Section	Revision - Addition	Description
782.13	Revised page nos. 5 and 5a	are enclosed as replacements. Mr. Wright's title has been changed.
782.13	A revised listing of officers and directors for Valley Camp of Utah, Inc., Valley Camp Coal Co., and Kanawha and Hocking Coal and Coke Co.	is enclosed as replacement page nos. 6 through 9a.
782.14	This section is updated with enclosed page nos. 16-18 through 16-36.	Insert behind page no. 16-17.
782.15	New page no. 22a is enclosed for insertion behind page no. 22.	This page corrects the Marakis Lease description found in paragraph 3 on page 22.
782.15	Revised page no. 44 is enclosed as a replacement for the same page in Appendix A.

84.11 OPERATIONS PLAN

Valley Camp of Utah, Inc. operates the Belina No. 1, and Belina No. 2 Mines at Whiskey Canyon, approximately 4½ miles south of Scofield, Utah. The mining is currently being conducted in accordance with a Mine Plan (30 CFR 211) approved February 10, 1977, and Utah Division of Oil, Gas and Mining Permits ACT/007/001 and ACT/007/014.

Figure 3-6C

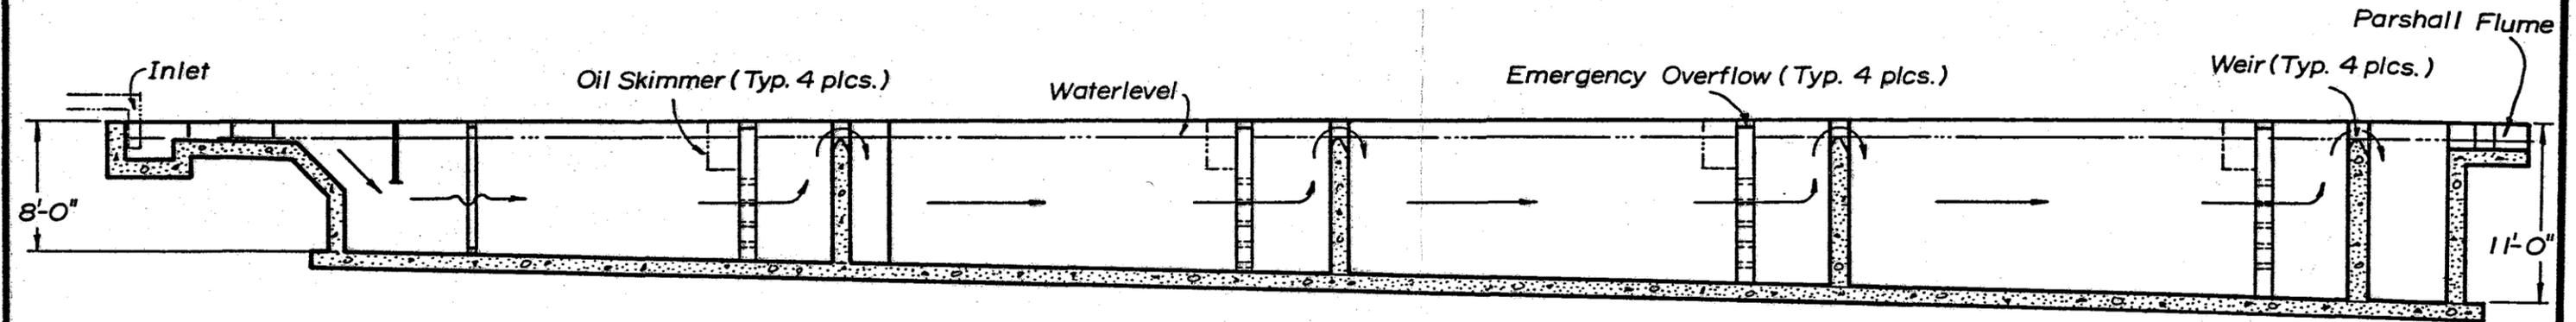
- 784.12 Revised page nos. 13 through 15 are enclosed as replacements. This revision reflects the change in frequency of sediment pond inspections.
- 784.12 A revised drawing, No. B4-0010, "Concrete Filter Pond," is enclosed as Figure 3-6C, page no. 20C, for replacement of that figure presently in the plan.

Figure 3-6D

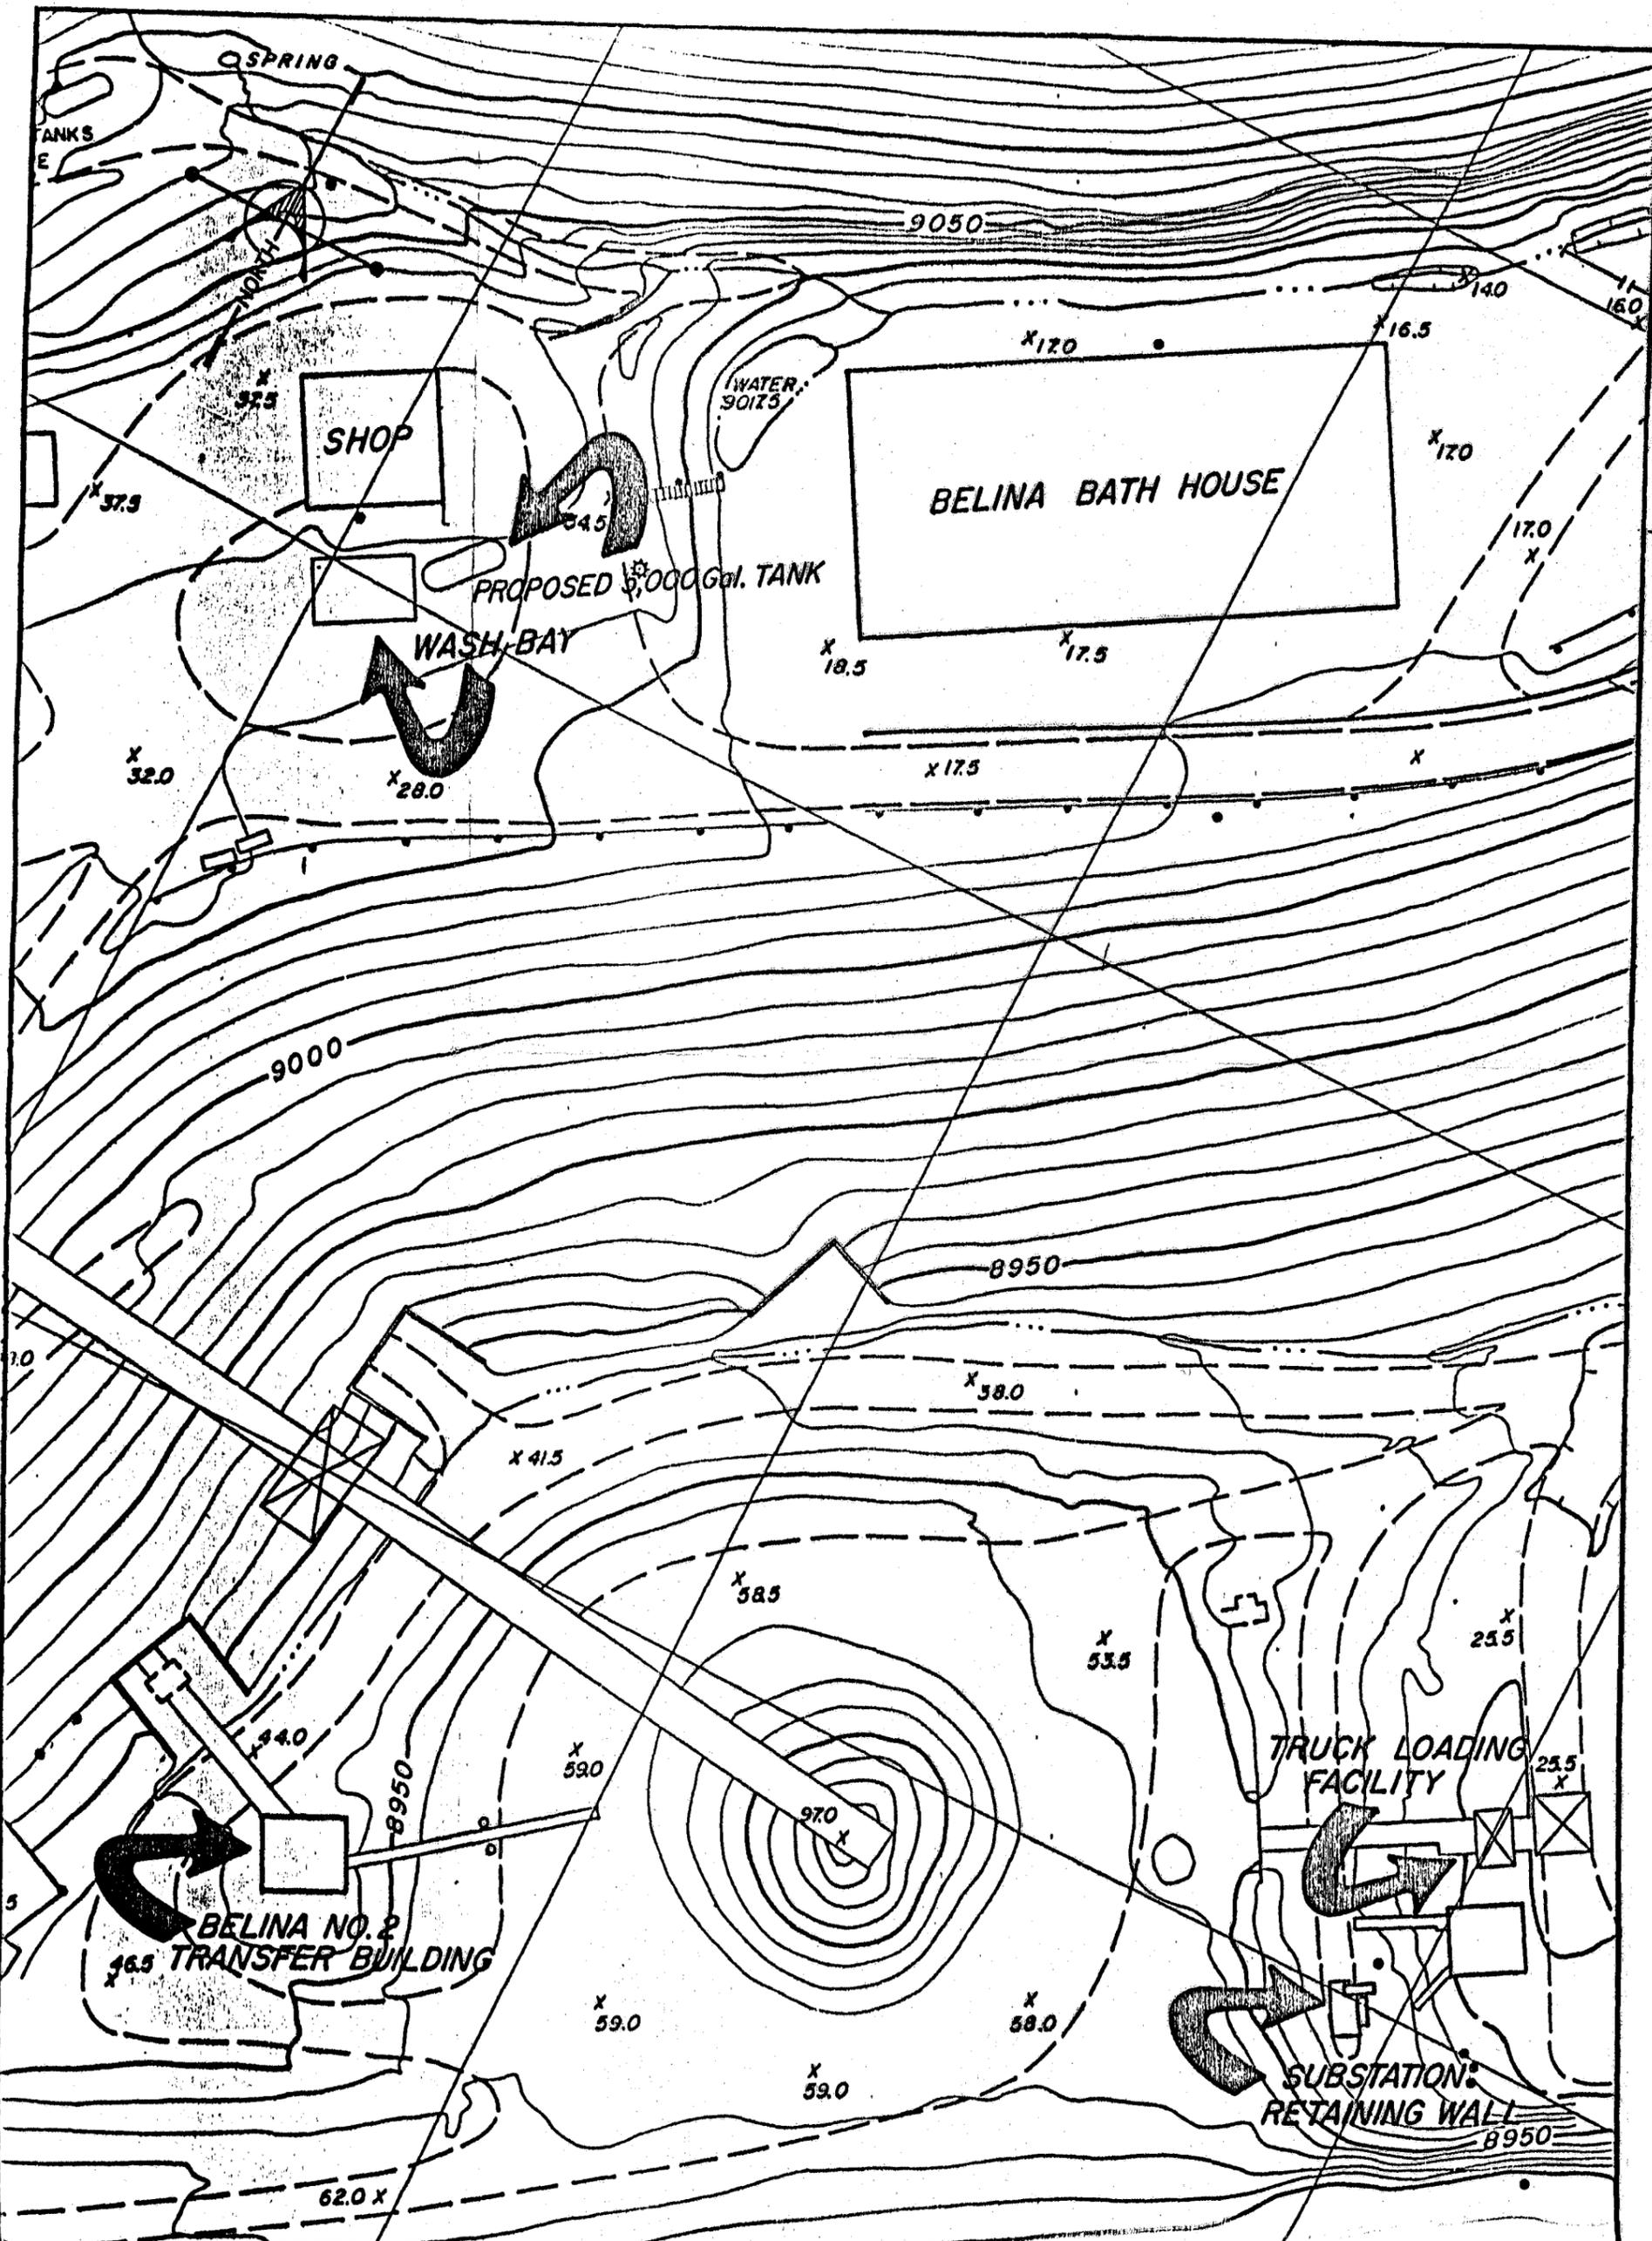
- 784.12 A new drawing, No. B3-0020, for typical gabion structures, is enclosed as Figure 3-6D, page no. 20D.
- 784.12 A new drawing, No. A4-0092, for typical decant pipes, is enclosed as Figure 3-6E, page no. 20E.

DRAWN BY: Ed Sanderson	DATE: Sept. 12, 83	 <b>VALLEY CAMP of UTAH</b> <b>SCOFIELD ROUTE</b> <b>HELPER, UTAH 84526</b>	
CHECKED BY:	DATE:		
REVISED BY:	SCALE: NONE		
APPROVAL ENG.:			
APPROVAL SAFETY:	TITLE: UTAH NO. 2 AREA TYPICAL ROAD CROSS SECTIONS	DRAWING NO. A5-0067	REV. NO. 1
APPROVAL MINE:

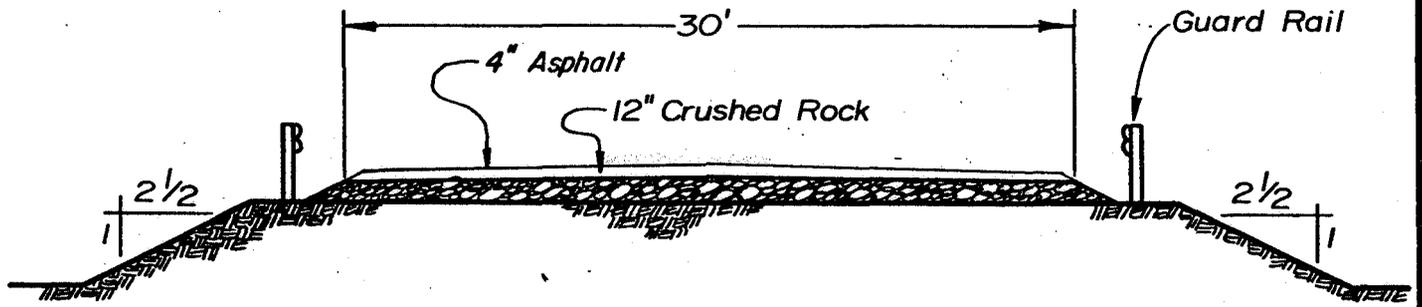
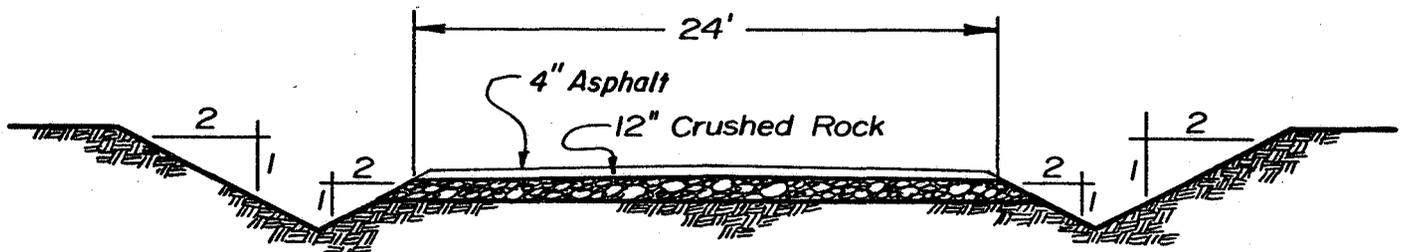
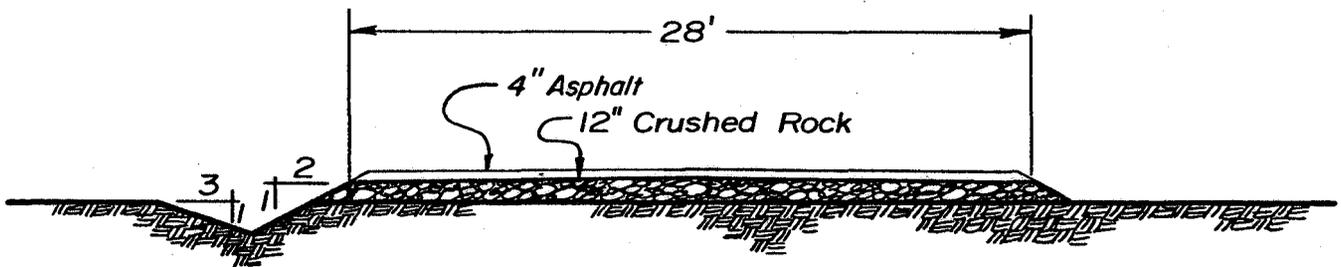
- 784.24 Page 92 has been revised to include recent road paving activities.
- 784.24 Figure 3-32, Drawing No. A5-0067, has been revised to show recent paving activities. This figure has been numbered as page no. 92A. Refer also to Map No. D4-0085, Envelope 9 of Volume IV, for general site location.

TITLE: UTAH NO. 2 POND - STAGE CAPACITY & CURVE  
 SCALE: NONE DRAWING NO. B-3-0033

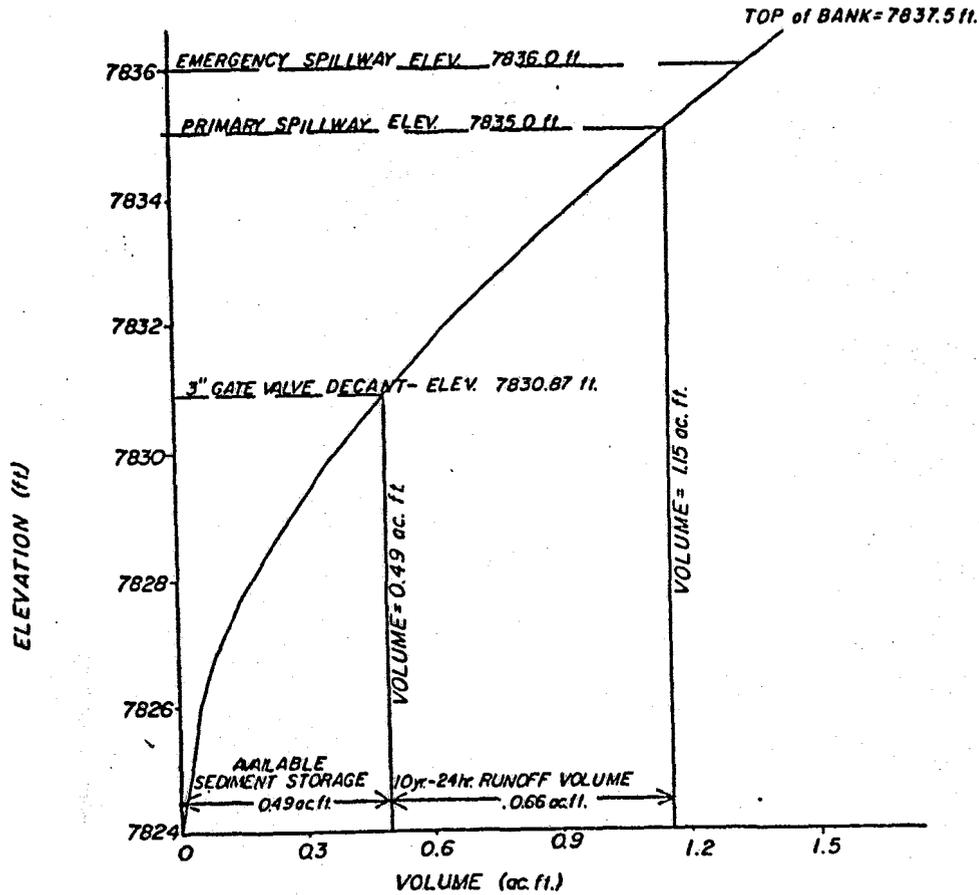
- 817.46  
[784.16  
(b) 1 &  
2] New page no. 10B-1, showing the new capacity of Sediment Pond No. 2, is enclosed for insertion behind page no. 10B of this section. New page no. 10B-2, Drawing No. B3-0033, "Utah No. 2 Pond-Stage Capacity and Curve," is also enclosed for insertion.
